Information note

N° 10375AERRA

Errata sheet V1.11 affecting products TC37x_AA

Errata Sheet

Figure 1 Message buffer transfer from Message RAM to OBF

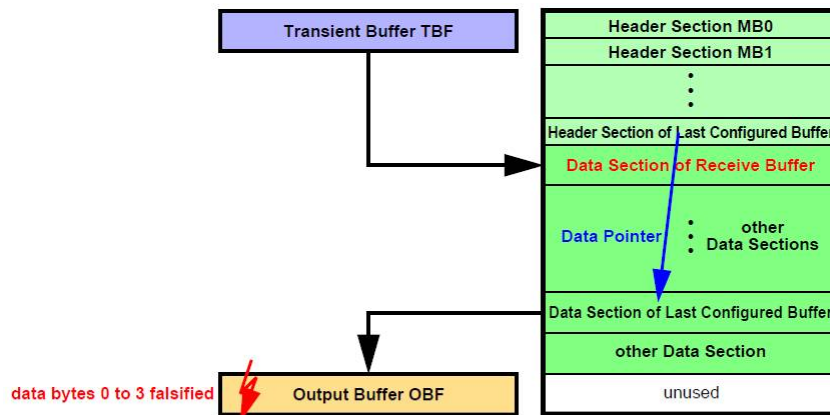
a) When a message is transferred from the Last Configured Buffer in the Message RAM to the OBF and **PLC** = 127 it may happen, that at the end of the transfer the OBF word on address 00h (payload data bytes 0 to 3) is overwritten with unexpected data (see [Figure 1](#)).

Figure 2 Message buffer transfer from IBF to Message RAM

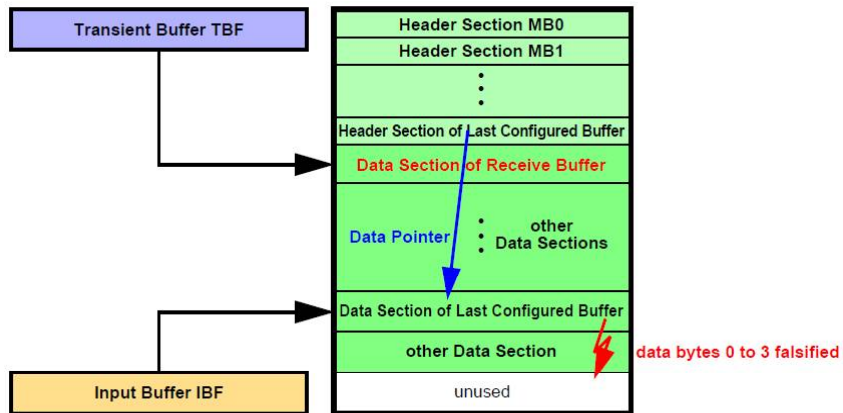
b) When a message is transferred from IBF to the Last Configured Buffer in the Message RAM, it may happen, that at the end of the transfer of the Data Section one additional write access overwrites the following word, which may be the first word of another message's Data Section in the Message RAM (see [Figure 2](#)).

Figure 3 Message RAM Configurations

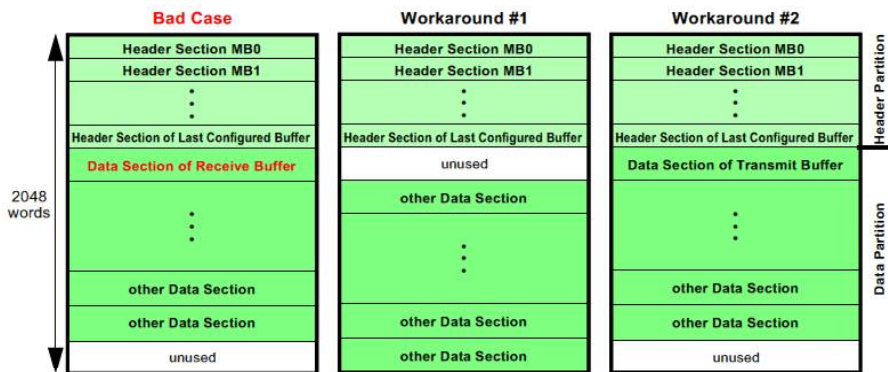
The erratum is limited to the case when (see [Figure 3](#) “Bad Case”):

2) Ensure that the Data Section directly following the Header Partition is assigned to a transmit buffer.

Figure 6 Critical MCS AEI master scenario

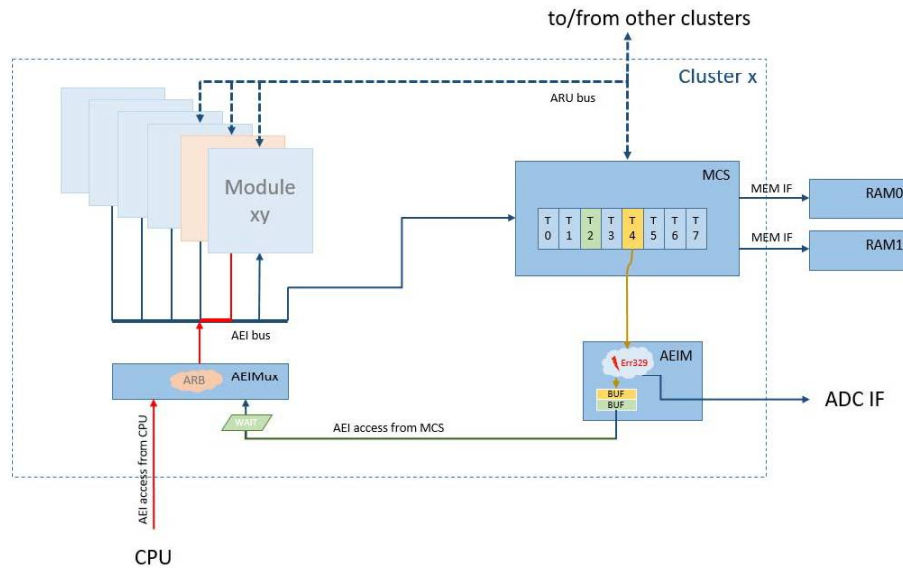
In [Figure 6](#), a potential risk for the occurrence of problem GTM_AI.329 is illustrated. Here the first buffer of the AEIM (green) is still waiting for the access to the AEI bus while a second AEI bus access from MCS arrives at the AEIM (yellow access path). Under certain, but for the user unpredictable timing conditions, this second AEI bus access arriving at the AEIM can trigger the misbehavior described in problem GTM_AI.329.

The workarounds described in the following section will ensure that not more than one AEIM buffer will be filled and therefore the occurrence of problem GTM_AI.329 is avoided. All workarounds have been tested and proven correct.

Figure 7 MCS token mechanism

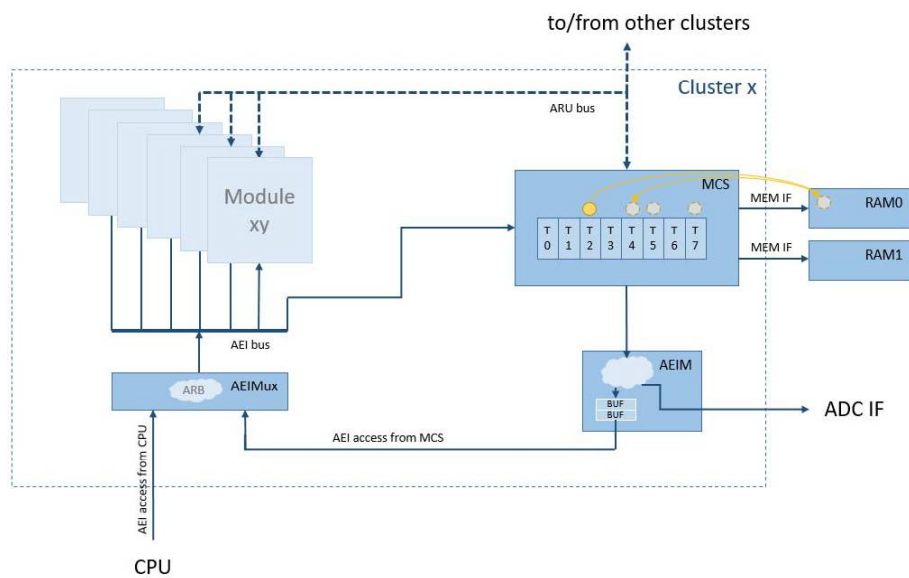
In case multiple MCS channels want to use the AEI master port for AEI or ADC communication, establish a mechanism that ensures that only one channel uses the AEI master at a time (e.g. exchange a token between channels or use trigger registers to hand over the AEI master port ownership between MCS channels).

An application note (AN020 – MCS Mutex implementation) describing a token exchange mechanism between MCS threads is available at Bosch. Such a token mechanism allows multiple MCS threads to safely access the AEI bus system by exchanging an AEI bus access token via MCS memory.

Figure 8 Interrupt Level vs. Pulse-Notify mode - Corner Case Example

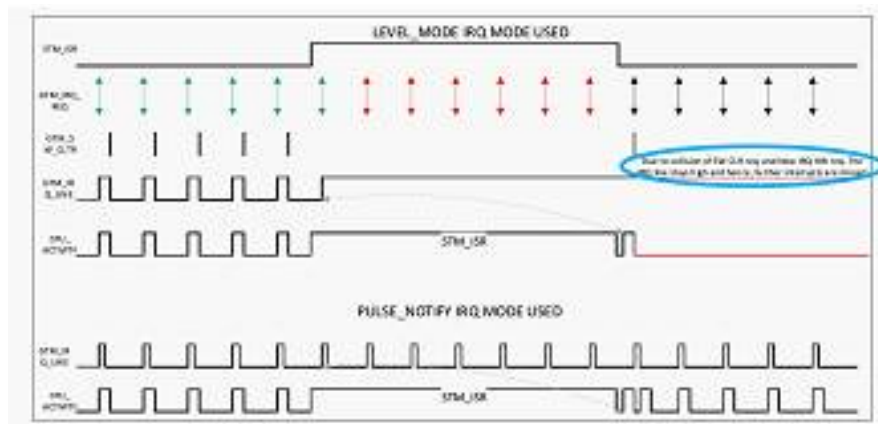
As described in the text below this figure, while using Level mode, if more internal “interrupt” events are generated (i.e. two TOM channels generating a CCU0 interrupt), just one interrupt signal is sent to the IR, and no more interrupts are triggered until the SW clears the GTM_IRQ_XXX line towards the IR.

Hence, in Level Mode, in some scenarios where another interrupt request is generated by GTM while the ISR handle also requests a SW clear, then, as the interrupt event is dominant over the clear event (for simultaneous interrupt and clear events), GTM_IRQ_XXX is not cleared and remains high. As a consequence, the IR observes no transition on GTM_IRQ_XX. Thus, any forthcoming interrupt events in this scenario are lost as there is no chance to release the CPU IRQ when a collision happens as shown in Figure below.

If Pulse-Notify mode is selected, every internal trigger will be forwarded to the IR, irrespective of the time of occurrence and the clear event, as the pulse-notify leads to set and reset of GTM_IRQ_XXX as compared to only setting of the GTM_IRQ_XXX line in Level mode.

Figure 9 Timing of LVDS TX interface command sending in relation to IRQ.IFCFS

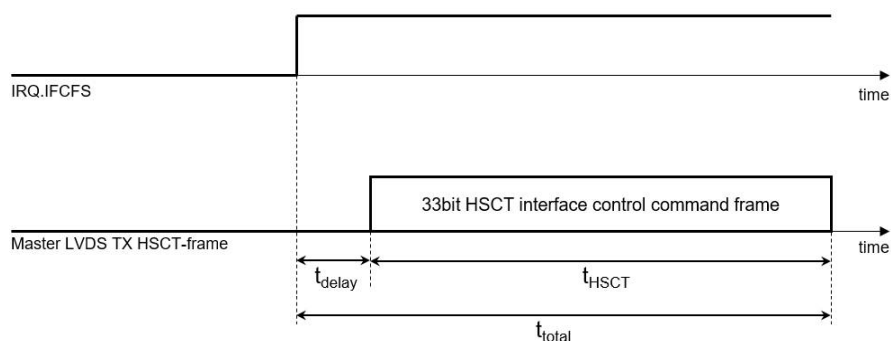
the user might falsely assume that also the actual sending on the LVDS TX port has already occurred once the IRQ.IFCFS flag is set, which is not true.

Instead the timing shown in [Figure 9](#) applies.

Figure 10 Package Outlines LQFP-176 for TC37x

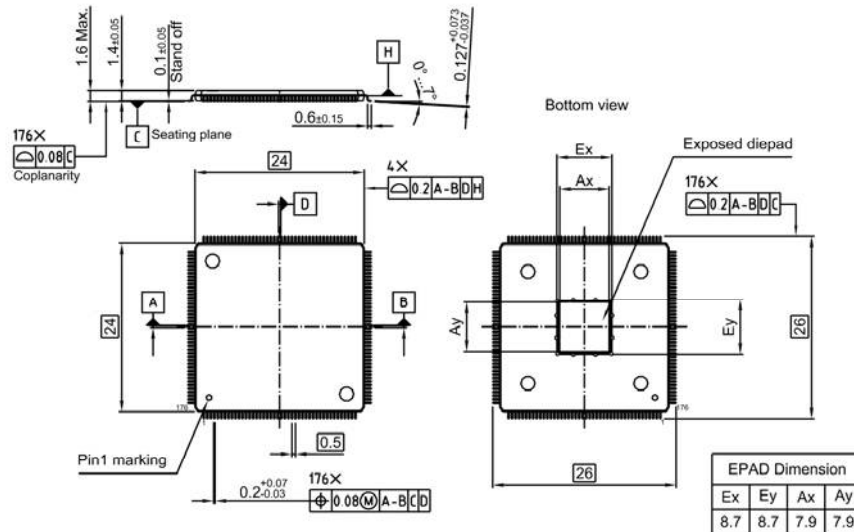
This information shall substitute the corresponding information in the TC37x AA-step Data Sheet V1.1.

Note: For the exposed diepad of the LQFP-176 package of the TC37x, structural corner protrusions have to be considered for purposes of system design and integration with a maximum boundary of 9.4 mm.

Figure 11 Positive overload on P-pad of a LVDS RX pin pair (both used as inputs)

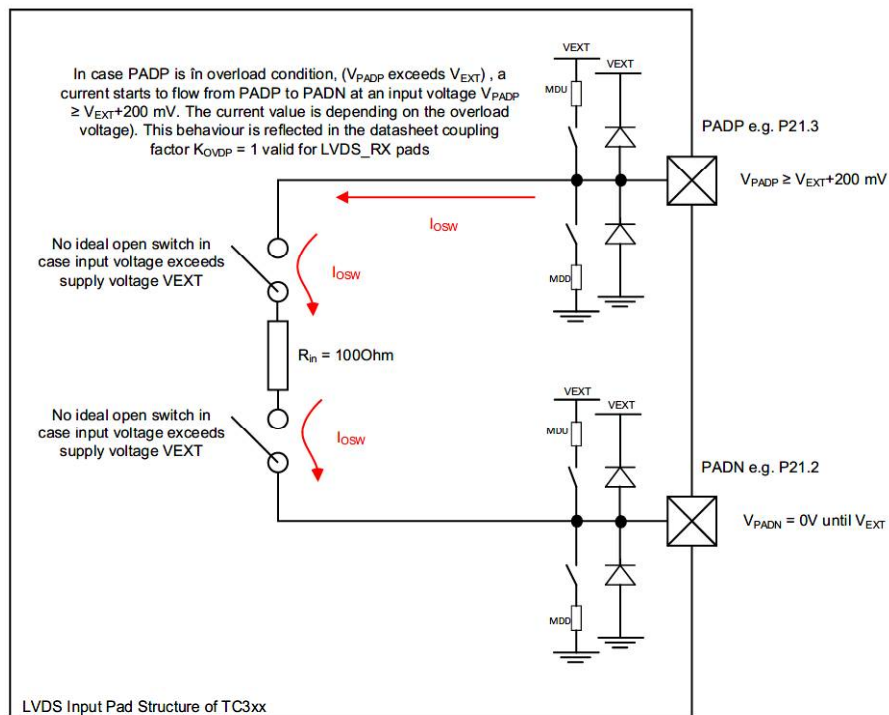
The following figure illustrates the effect for a positive overload condition ($V_{PADP} > V_{EXT}$) on the P-pad (PADP) of a pin pair where both the P-pad and the corresponding N-pad (NPAD, with $0V \leq V_{NPAD} \leq V_{EXT}$) are used as digital CMOS inputs.

The overload current I_{OSW} through the non-ideal open switch significantly increases when $V_{PADP} \geq V_{EXT} + 200\text{ mV}$.

Note: In general, the effect will also occur if the N-pad is used as output, or for a negative overload condition on either the P-pad or the N-pad.
